Solis/Kodak Hybrid and
US3000C/US2000C/UP5000

Changes to the pinout of the CAN communication has been made on the newer Pylontech batteries.

Figure 4: Option 2 configuration

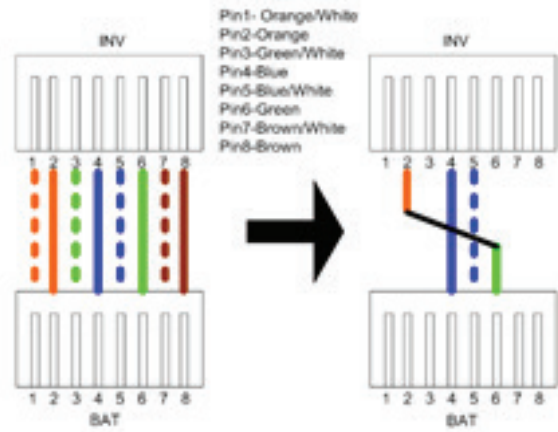
The included BMS cable on the Solis inverters still uses pin 2 which may cause issues with BMS communication this will need to be corrected.

Option 2: A new cable can be made with pin 4 and 5 used for CAN-H and CAN-L respectively. Then the GND pin connected as shown in Figure 4.
